Skyline Subdivision

DSP-19059

STAFF REPORT

SUBJECT: Detailed Site Plan DSP-19059
 Type 2 Tree Conservation TCP2-016-2021
 Skyline Subdivision

Figure 1: Site Plan

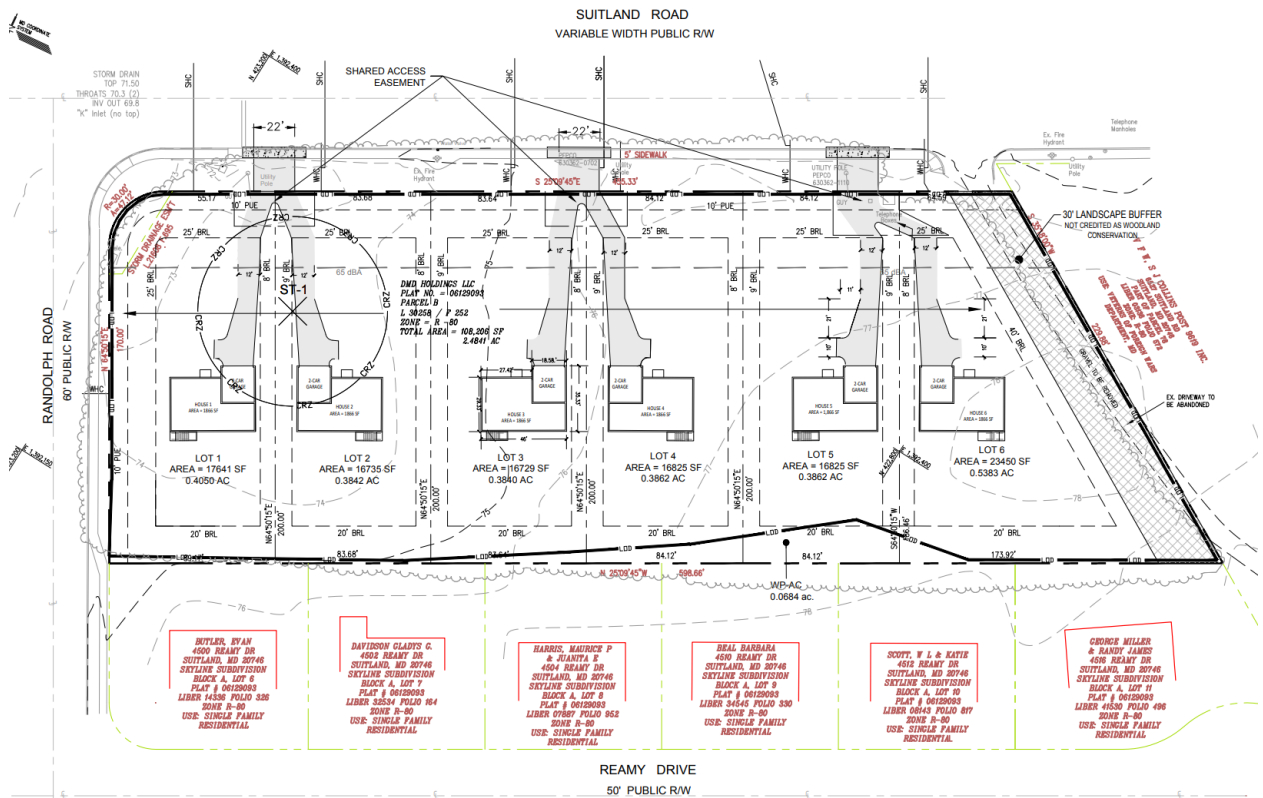
The DSP does not clearly indicate a 10-foot-wide landscape strip along the front of Lots 1 through 6 with appropriate plant units and materials, outside the 10-foot-wide public utility easement. A condition is included herein requiring this to be provided and labeled on the plans.

The DSP reflects three shared access points to Suitland Road. However, the plans should also reflect denial of access to Suitland Road and Randolph Road, except for the three allowed access points, as conditioned herein.

1. Prior to certification, the detailed site plan (DSP) shall be revised, or additional information shall be provided, as follows:
 - a. Revise the plans to provide the Military Installation Overlay Zone height calculations to demonstrate conformance with Section 27-548.54(e)(2)(B) of the Prince George's County Zoning Ordinance.

- b. Provide a 10-foot-wide landscape strip along the front of Lots 1 through 6 with appropriate plant units and materials, outside the 10-foot-wide public utility easement.

- c. Show and label denial of access to Suitland Road and Randolph Road, except for the three shared driveway access points to Suitland Road.
 - d. Provide the dimensions of the front porch/stoop, indicate if it is covered, and provide the dimensions of the optional extension and optional chimney.

- f. Provide the actual setbacks from the house to each property line on the site plan for all lots.
 - g. Demonstrate the lot coverage and height of the houses on the site plan.

- h. Show the proposed grading and stormwater management features on the DSP.
 - i. Provide the amount of the fee-in-lieu of the mandatory dedication of parkland in the General Notes of the DSP.
